Interactive comment on “Evaluating the spatio-temporal performance of sky imager based solar irradiance analysis and forecasts” by T. Schmidt et al.

Received and published: 12 February 2016

Fig. 1.

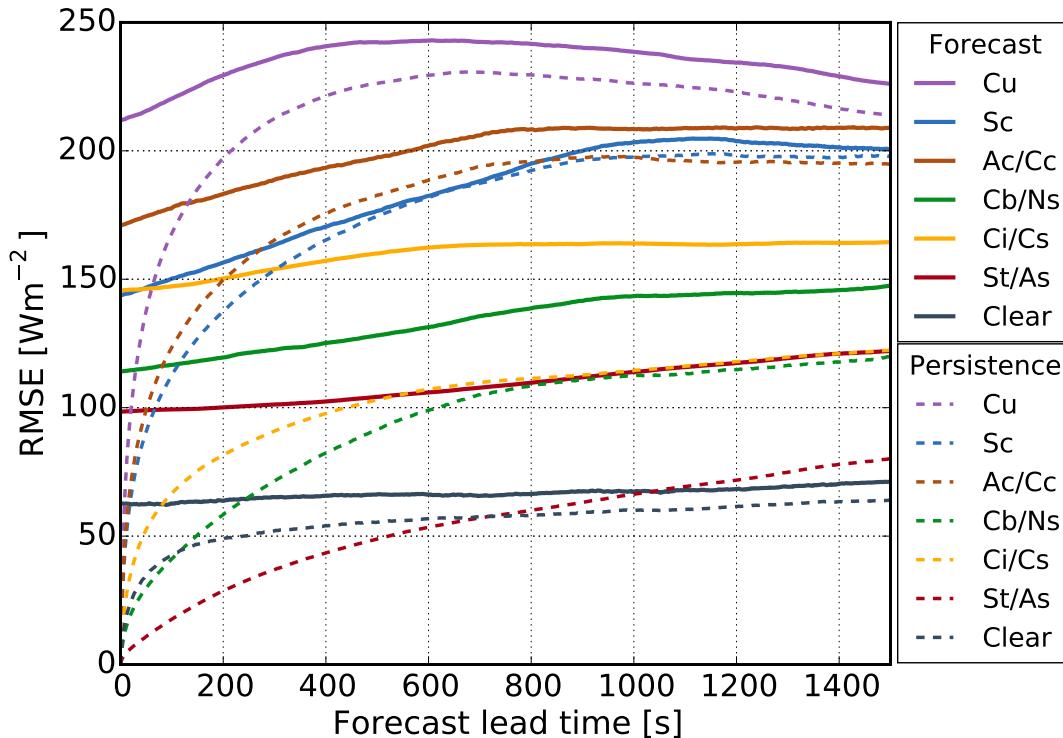
- We applied all proposed corrections
- p.27015, line 25 changed to "...contributing to RMSE and a positive MBE"
- colors in Fig.12 and 14 (RMSE vs Lead Time and Accuracy vs Lead Time) have been changed aiming at a better discrimination of single overlapping lines.

Figure 12 and 14 as described in the response on the reviewer's comment.
